TIME SAVER

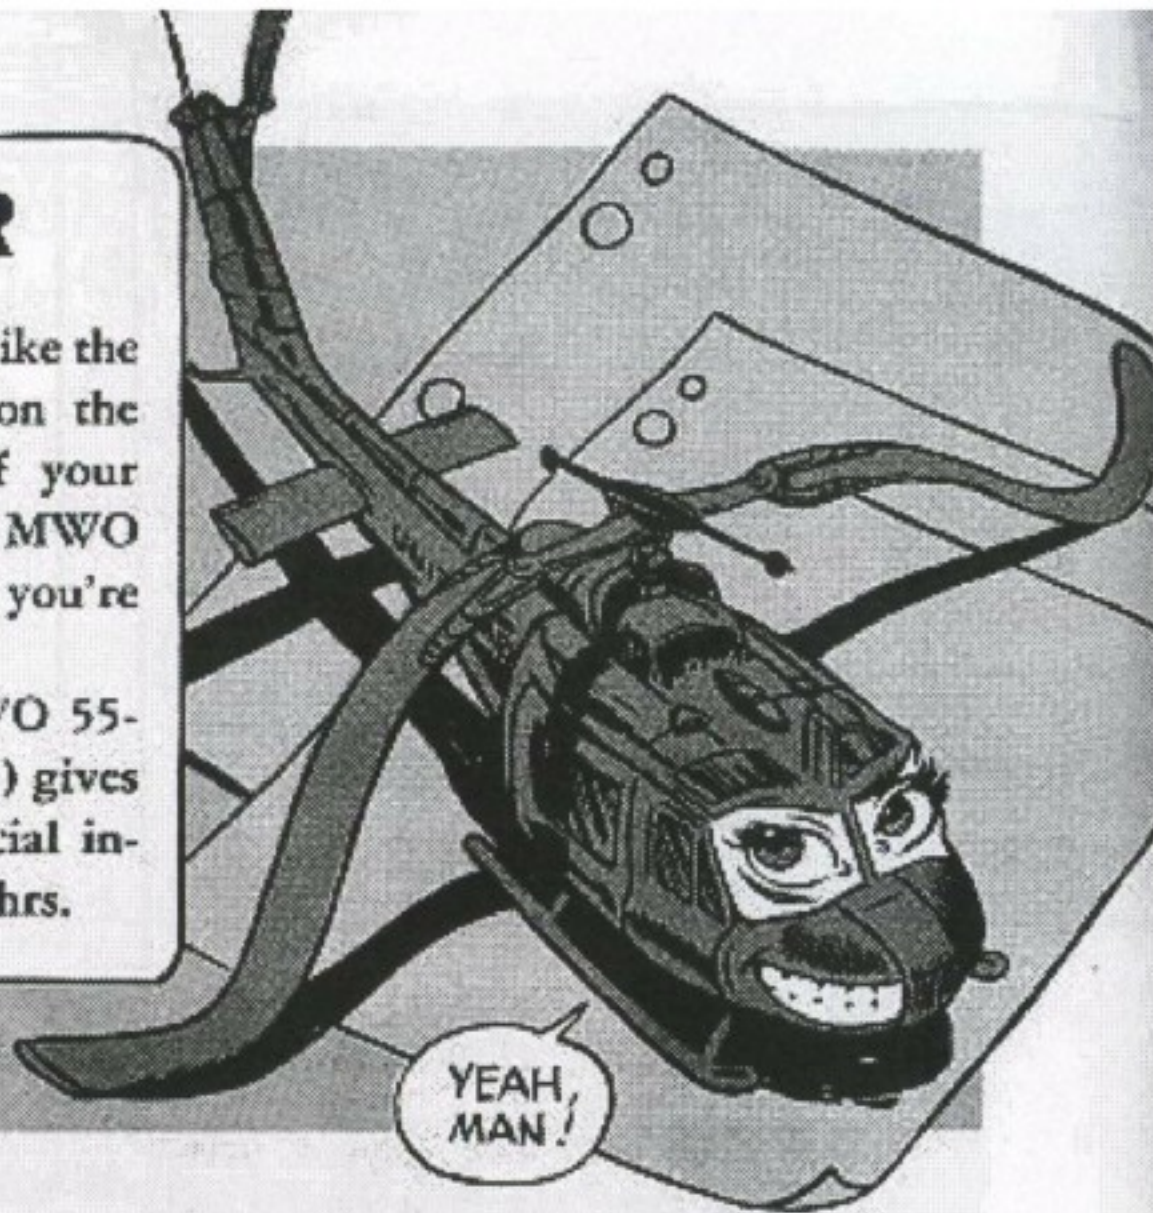
MWO's pay big dividends—like the improved grip retention nuts on the Huey 540 main rotor hub. If your Charlie model didn't get 'em, via MWO 55-1520-211-30/18 (15 Jul 66), you're missing a good bet.

The mod, together with MWO 55-1520-211-30/23, Ch 2 (9 Feb 67) gives you an increase in the hub special inspection time from 200 to 600 hrs.
